Access Compliance Report Public Rights-of-Way (Curb Ramps)

Main Street: GLENMERE_DR Cross Street: CASTLEGATE_LN Location: E

ADA ID: RPRK211008133137 Ramp Type: Type 1 - Perpendicular Diagonal Initial Pass/Fail: Fail Overall Compliance: No Severity Score: 30

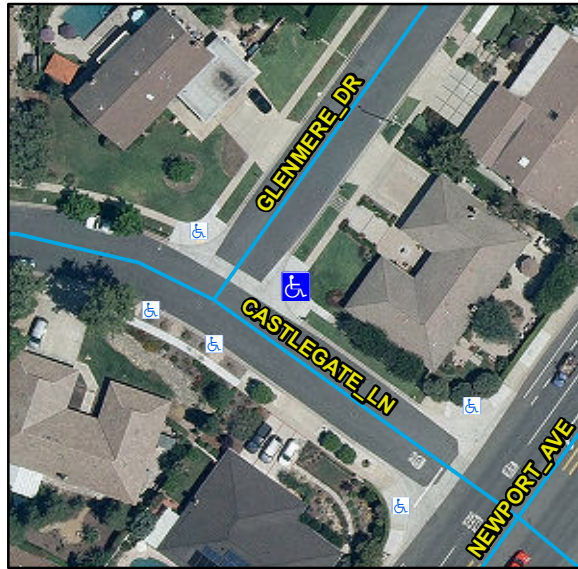
Compliance	Description	Data	Compliance	Description	Data
N/A	Ramp Length (in)	120	N/A	Flare Type LT	
Yes	Ramp Width (in)	48			N/A
No	Ramp Run Slope (%)	11.6	N/A	Flare Slope LT (%)	N/A
No	Ramp Cross Slope (%)	5.7	N/A	Flare Traversable LT	N/A
N/A	Landing Present	N/A	N/A	Flare Type RT	
N/A	Landing Length (in)	N/A			N/A
N/A	Landing Width (in)	N/A	N/A	Flare Slope RT (%)	N/A
N/A	Landing Run Slope (%)	N/A	N/A	Flare Traversable RT	N/A
N/A	Landing Cross Slope (%)	N/A	N/A	DWS Provided	N/A
N/A	Landing Movement Obstructed?	N/A	N/A	DWS Contrast	N/A
	Landing Movement Type	N/A	N/A	DWS Length (in)	N/A
N/A	Landing Shared	N/A	N/A	DWS Full Width	N/A
N/A	Clear Space	Yes	N/A	DWS Offset Left (in)	N/A
N/A	Clear Space To Crosswalk (in)	N/A	N/A	DWS Offset Right (in)	N/A
N/A	Marked Crosswalk 1	No	N/A	Marked Crosswalk 2	No
	Crossing 1 Direction	NE		Crossing 2 Direction	NW
	Marked Crosswalk 1 Width (in)	N/A		Marked Crosswalk 2 Width (in)	N/A

Remove & Replace Curb Ramp With Two New Directional Ramps or Equivalent.
